STAFF REPORT
CONCERNING APPLICATION FOR A
CERTIFICATE OF APPROPRIATENESS

Date: October 9, 2018

Application Number: 2018-1001D

Property Location: 720 Park Avenue

720 PARK AVE ROUGH SITE PLAN
(NOT TO SCALE)

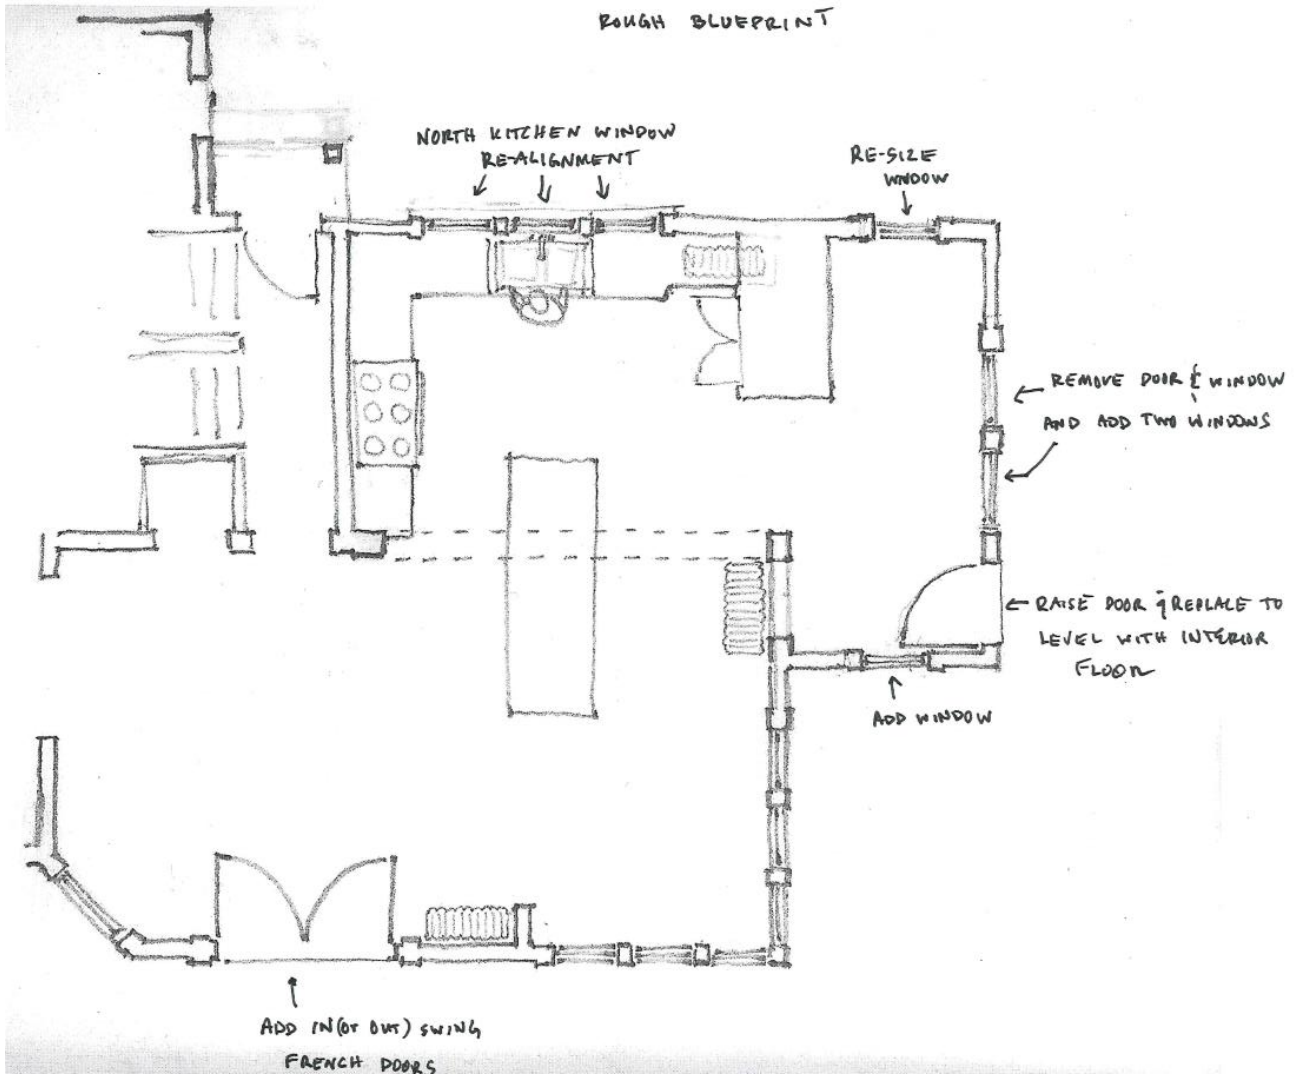
REPLACE { RE-SIZE WINDOW
TO MATCH NEW WINDOW
ADDITION ON SOUTH WALL
(DIRECTLY OPPOSITE)

PROPOSED 3 KITCHEN WINDOW RE-ALIGNMENT

REMOVE & REPLACE 3 WINDOWS; REPOSITION LOWER WITH 27" X 56" KITCHEN OVER THE SINK WINDOWS

STAFF RECOMMENDATION: Approval of placement and material of window and door adjustments/additions. Remand authority to staff for specific window and door selection. Of the provided examples, 1/1 double hung window style is preferred over casement.

Figure 7—720 Park, windows to French doors

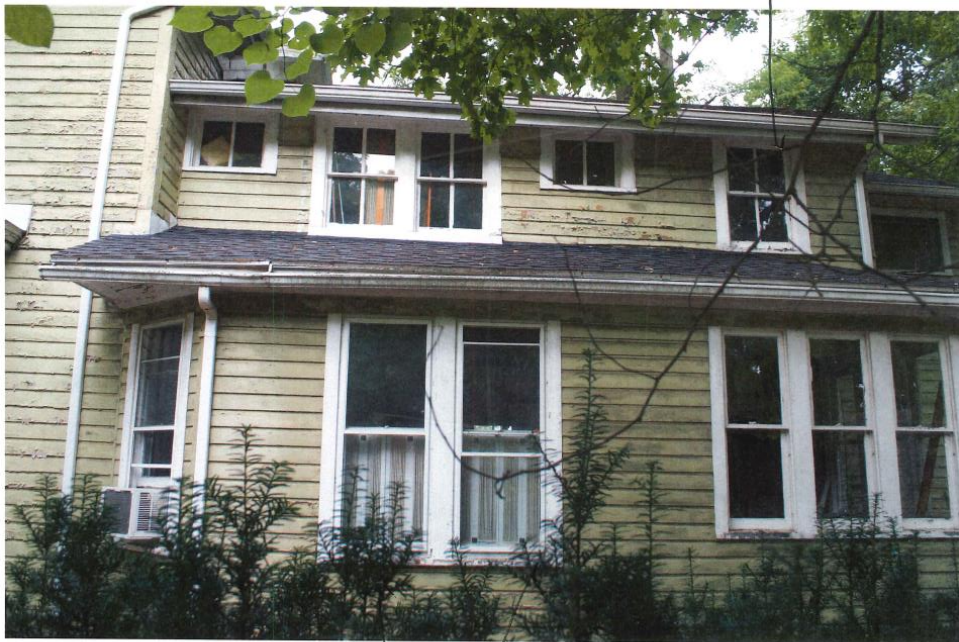
REPLACE DAMAGED WINDOW ABOVE

FRENCH DOOR PLACEMENT
(INTEGRATED INTO SOUTH ELEVATION)

Figure 8—720 Park, windows and door adjustments

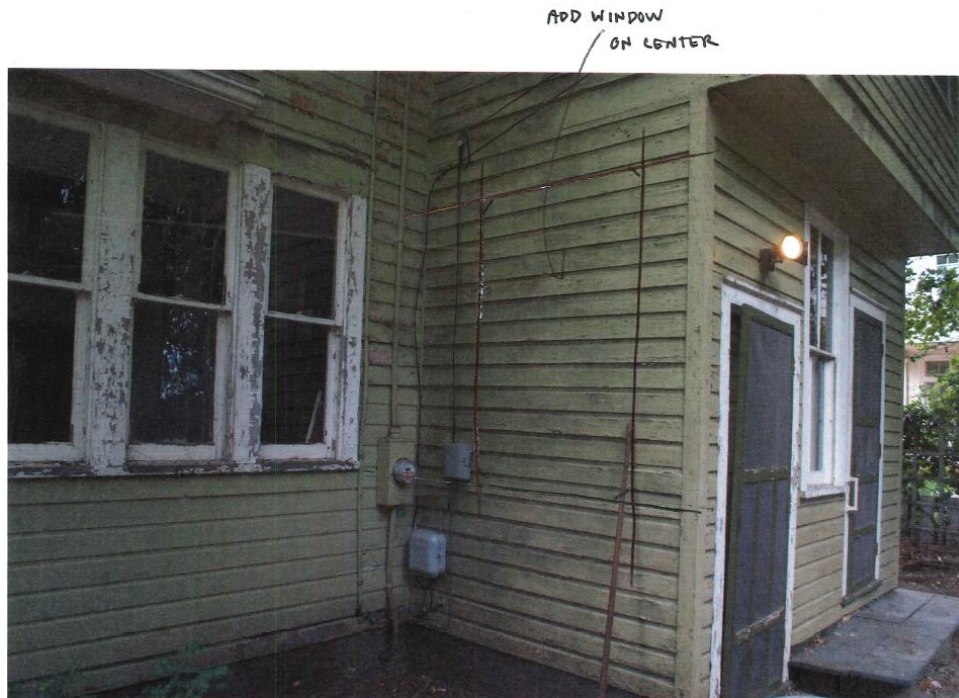
↑
RAISE DOOR AND
REPLACE WITH FRENCH/PATIO
DOOR

↘ REMOVE DOOR & REPLACE WINDOW
AND DOOR WITH 2 WINDOWS

Proposed window and door options

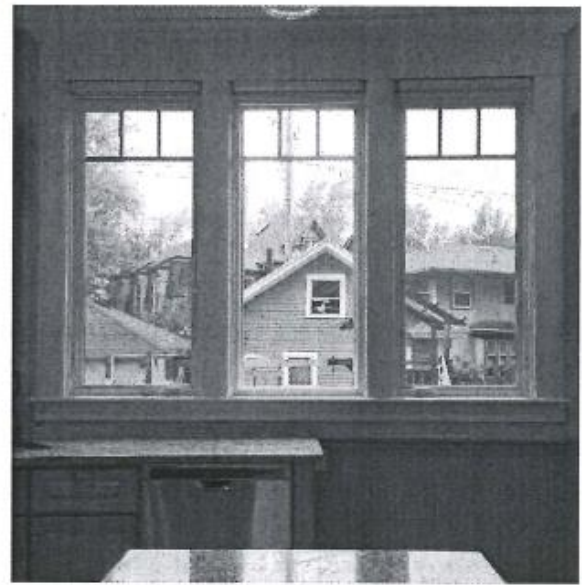
**Ashworth Professional Door
Door**

Marvin Ultrex Out Swing French

**Marvin Ultimate Casement Windows on kitchen project approved by HPC on Lamonte
Terrace**
